Re: Bubba's 33
10000 Coors Blvd Bypass NW
Traffic Circulation Layout
 Engineer's/Architect's Stamp 07-11-24 (B14D004H)

Based upon the information provided in your submittal received 07-12-24, the above referenced plan cannot be approved for Building Permit until the following comments are addressed:

TABLE 7.4.78 Dimensions for Standard Angle Parking

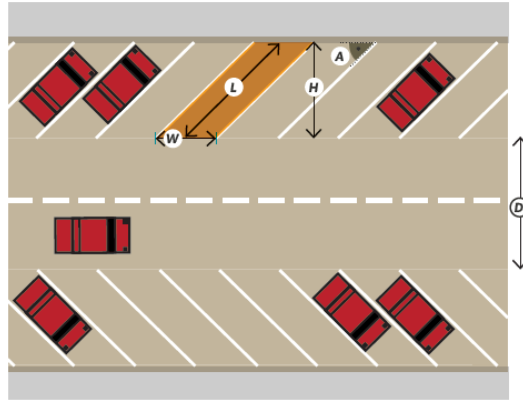
1. Please identify all existing buildings, doors, structures, sidewalks, curbs, drive pads, wall and anything that influences the parking and circulation on the site.
2. The site location looks like already an existing parking space for another facility. Please provide if any kind of approval/agreement was sought.
3. For transportation approval please provide a separate set of drawings showing the site plan and related transportation details (ADA Sign, bike rack, ADA parking etc.).
4. All accessways to the site from the adjacent roadway shall be ADA-compliant. Provide an ADA pathway from existing sidewalk to building.
5. The minimum parking stall dimensions for angle parking are:

Angle (A)	Stall Length (L)	Stall Width (W)	Stall Depth (H)	Drive Aisle (D)
30°	32.7 ft.	17 ft.	16.4 ft.	11 ft.
45°	26.5 ft.	12 ft.	18.7 ft.	11 ft.
60°	22.9 ft.	9.8 ft.	19.8 ft.	15 ft.
75°	20.3 ft.	8.8 ft.	19.6 ft.	22 ft.
90°	18 ft.	8.5 ft.	18 ft.	24 ft.

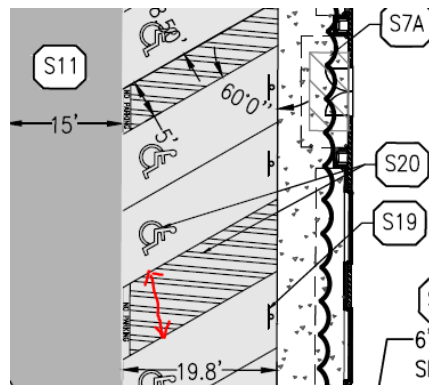
6. Show the dimension of Van accessible aisles in the ADA accessible spaces. Also clarify whether these aisles are flush with the ramp.
